**NLR-N89141**

REQUEST FOR ADDITIONAL INFORMATION  
NUREG 0737 ITEM II.D.1  
SALEM GENERATING STATION  
UNIT NOS. 1 AND 2  
DOCKET NOS. 50-272 AND 50-311

## NRC QUESTIONS AND RESPONSES

ATTACHMENT TO  
 CALCULATION  
 S-C-R200-MDC-091  
 REV. 1

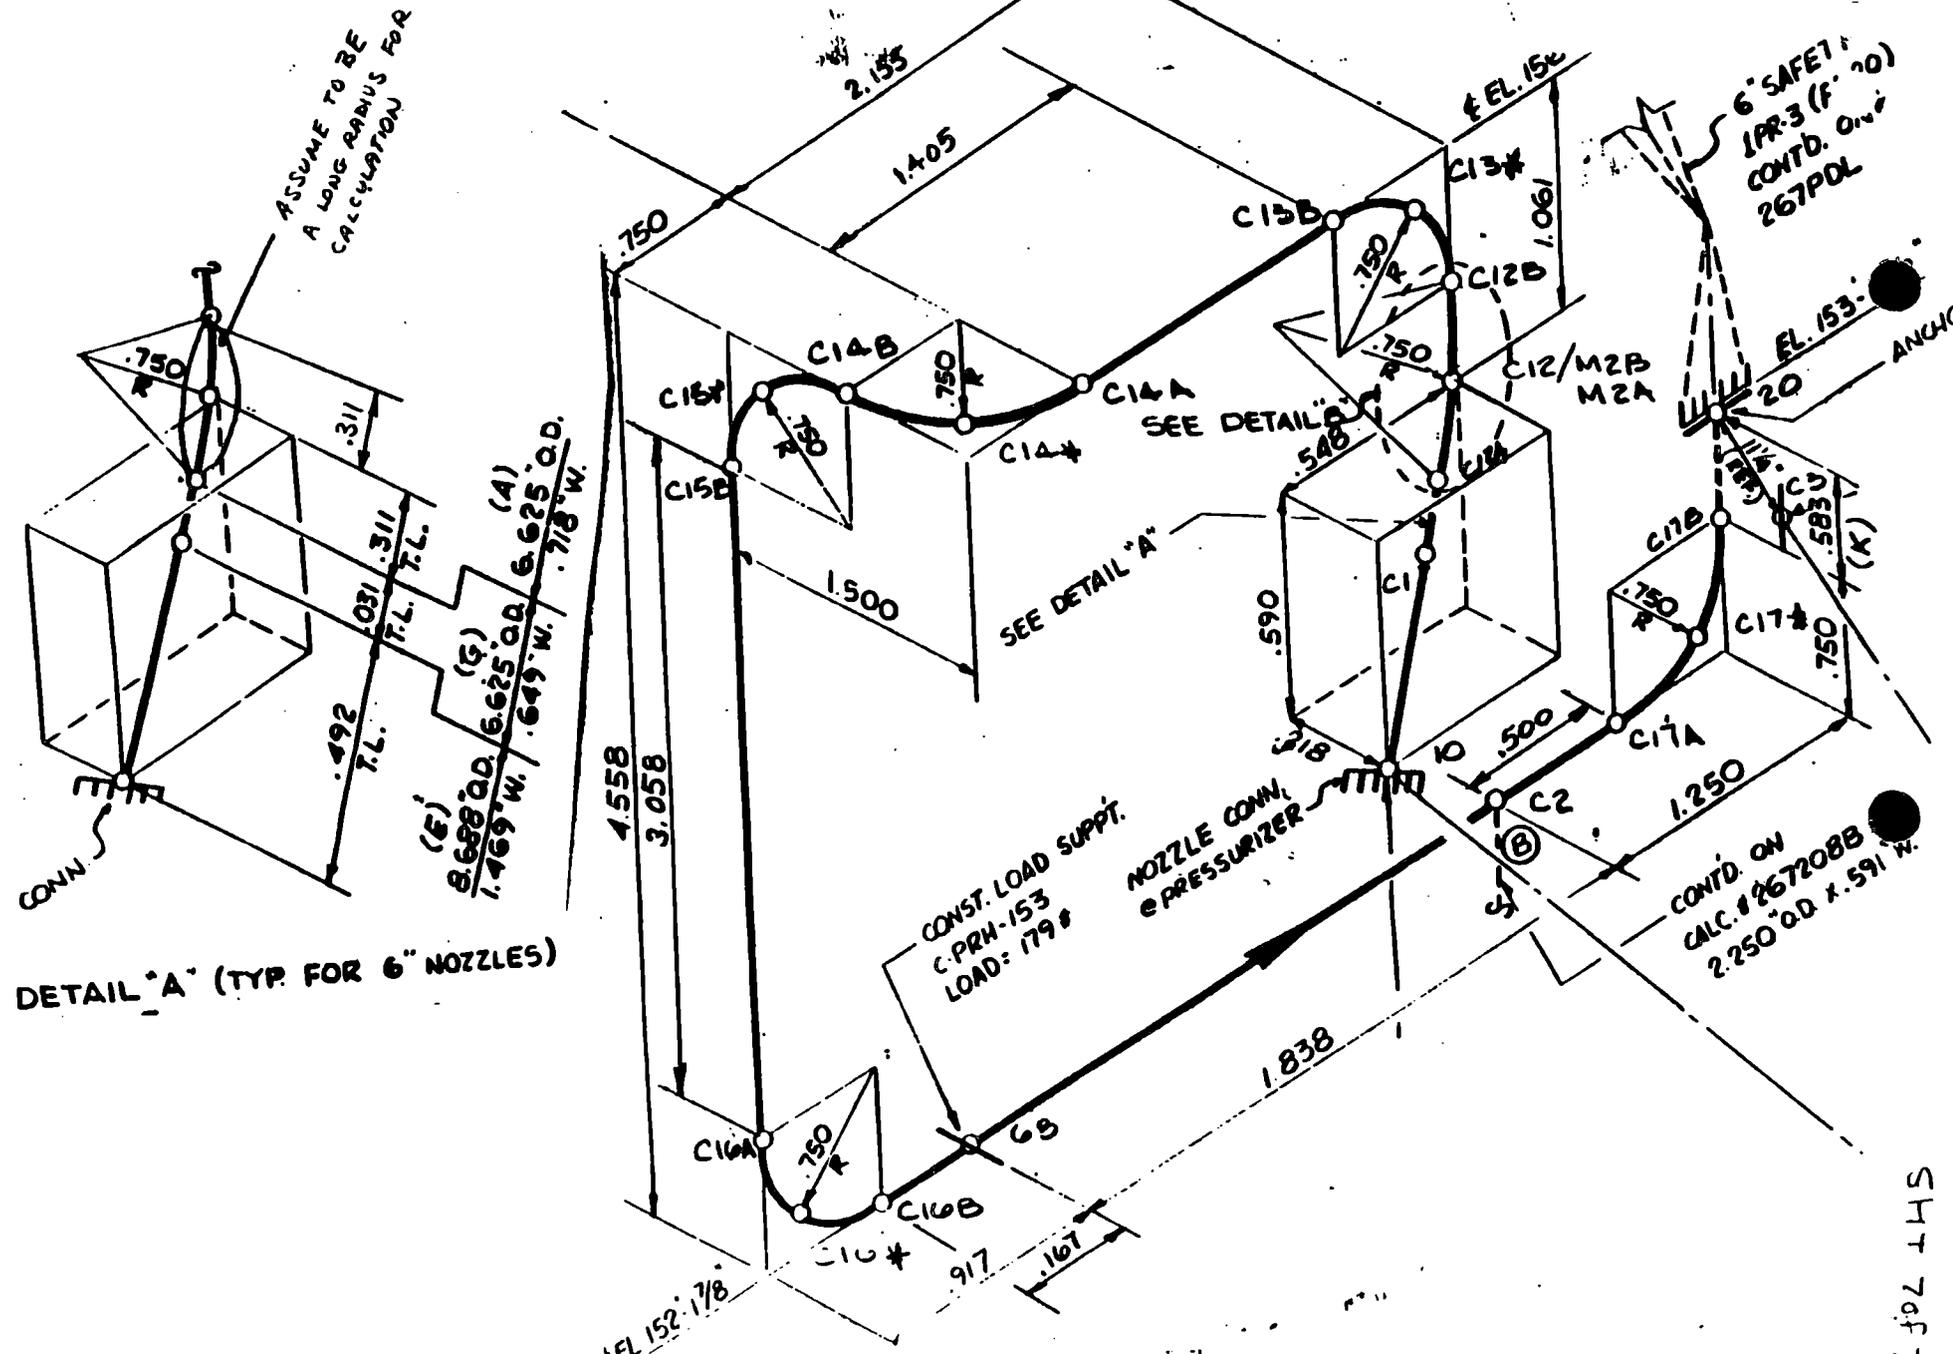
Isometric of inlet piping to 1PR3 - the one with  
the longest run is attached hereto.

The pipe has 8.7' of straight pipe  
and 5 90° long radius bends with 9" radius.  
( $r/d = 1.735$ ) [Equivalent length of these  
90° bends = 16 [Based on Crane A-27 1969]  
[Based on Crane A-29 1982]

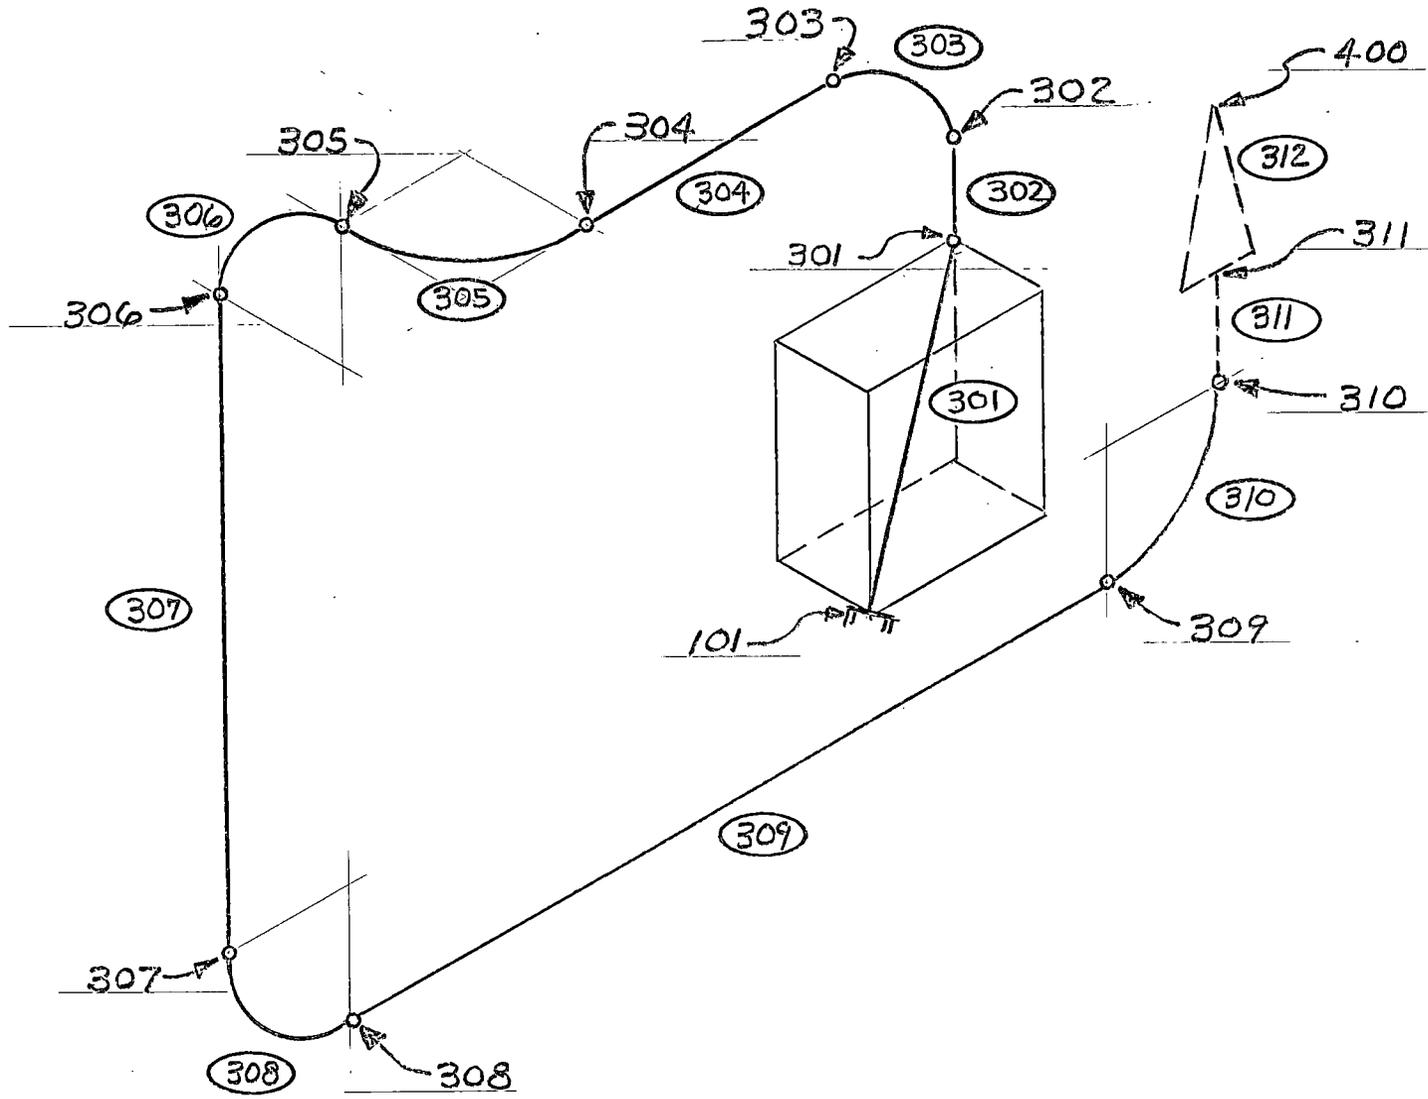
In the discussion of the thermal hydraulic analysis in Reference 2, the Licensee did not provide information on the loop seal temperature distribution used. Since the fluid forces acting on the piping system can be significantly affected by the loop seal temperature assumed in the analysis, show the loop seal temperature profile used in the thermal hydraulic analysis and provide a field verification by comparing the assumed temperature with the actual temperature measured at the plant.

The loop seal temperature distribution used in the stress analysis for the longest inlet loop seal of all Salem Units 1 & 2 valves are provided in Attachment 2. Node numbers are identified in Sketch 1. Also attached is Sketch 2 showing the loop seal arrangement and Sketch 3 showing the projected loop seal temperature profile developed by Diamond Power, Inc., the designer of the loop seal insulation.
